SOUTHWEST RESEARCH AND INFORMATION CENTER

May 20, 2013

RE: WIPP Class 3 Permit Modification Requests – Panel Closure System,
Repository Reconfiguration, and VOC Monitoring Program Revisions

FIGURE 1

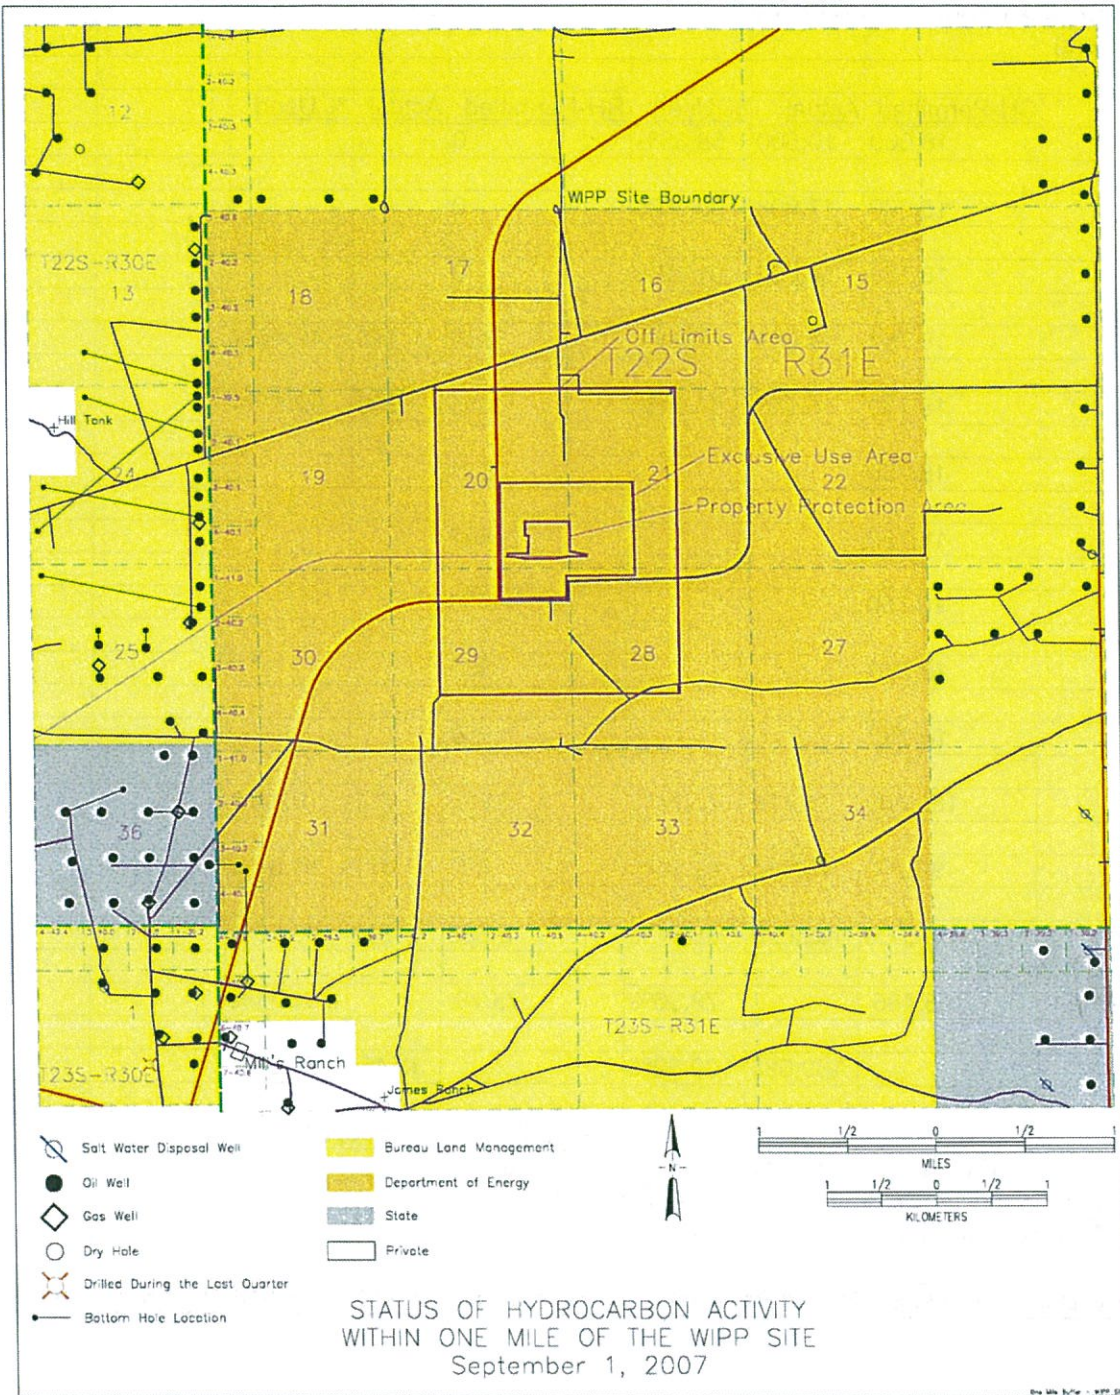
For example, results of borehole and probe holes surrounding Panels 4 and 5 are not provided. Further, moving panels closer to the southern boundary would result in waste emplacement closer to existing oil wells on the southern boundary of WIPP. Figure 1. That figure is as of September 1, 2007 and additional wells have been drilled in the vicinity of the WIPP site during the past 5+ years. The permittees should provide a current description and map of existing wells. Extending the panels further south will bring waste rooms closer to those wells. The permittees should provide an analysis of the impacts of drilling or other activities during the proposed almost 20 years of the continuing operation.

SRIC requests that in a response to a Notice of Deficiency or other method that the permittees provide the geophysical analyses and reports for the area surrounding Panels 4 and 5, including any features that could impact the performance of the two proposed panels. Further, the permittees should provide the location of oil and gas wells and other activities in proximity to

Panels 9A and 10A and analysis of how those activities could impact the performance of the panels.
